**UNITED STATES
NUCLEAR REGULATORY COMMISSION
ADVISORY COMMITTEE ON REACTOR SAFEGUARDS
WASHINGTON, DC 20555 - 0001**

SUBJECT: CERTIFIED MINUTES OF THE ACRS RELIABILITY AND PRA
SUBCOMMITTEE MEETING ON NUREG-1855, REV.1,
"GUIDANCE ON THE TREATMENT OF UNCERTAINTIES
ASSOCIATED WITH PRAS IN RISK-INFORMED
DECISIONMAKING", ON JUNE 19, 2012

**ADVISORY COMMITTEE ON REACTOR SAFEGUARDS
MINUTES OF THE ACRS RELIABILITY AND PRA SUBCOMMITTEE MEETING
JUNE 19, 2012**

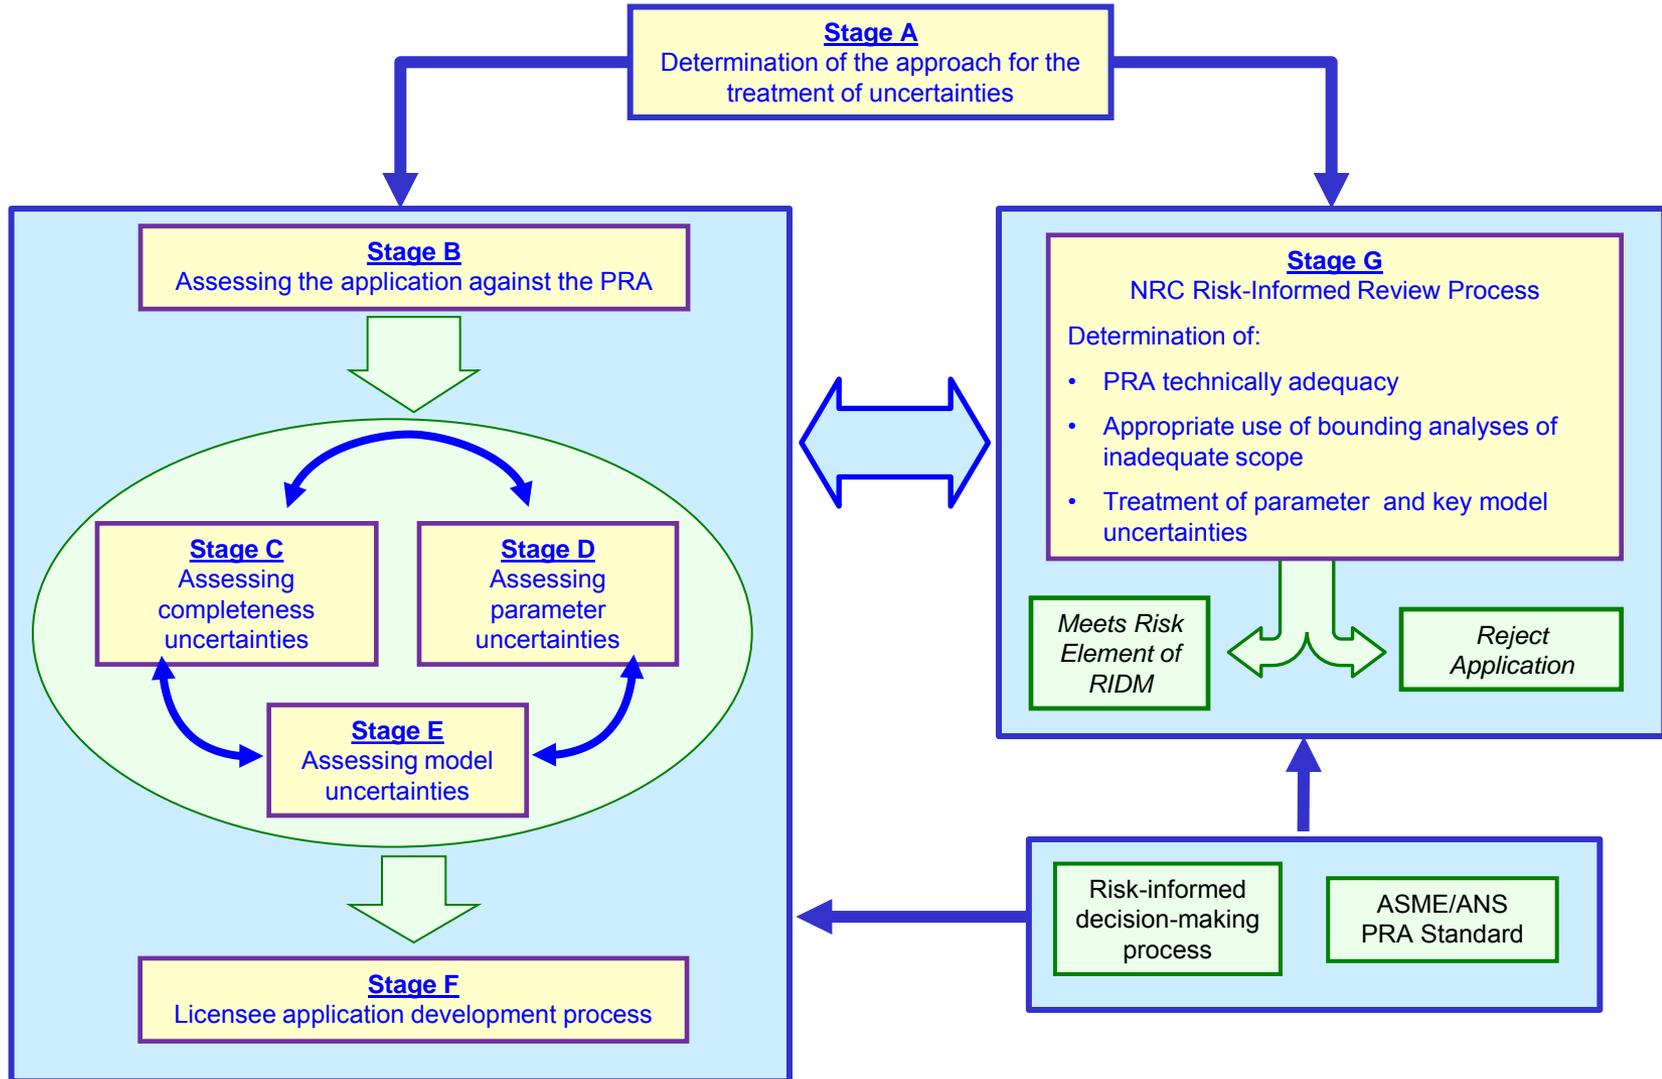
16 CHAIR STETKAR: One of the things, Mary,
17 and this is kind of, for me anyway, a fairly important
18 philosophical issue. This drawing in the NUREG draws
19 a nice, clean dotted line around what the NUREG
20 addresses. And it shows that little excerpt from
21 deterministic analyses as assessing the impact on
22 defense-in-depth and safety margins.

4 There's a drawing that's similar to this
5 in Reg Guide 1.174 that doesn't show this crisp dotted
6 line, and indeed it shows direct crosstalk between
7 deterministic analyses for safety margins and PRA
8 analyses. So the NUREG has separated that out. And
9 that's different. And that's an important difference
10 for me.

10 CHAIR STETKAR: -- but it seems to be part
11 of the philosophy of it. And this, as I said, this
12 particular drawing draws a very clear distinction that
13 isn't drawn in 1.174. You know, it just isn't.
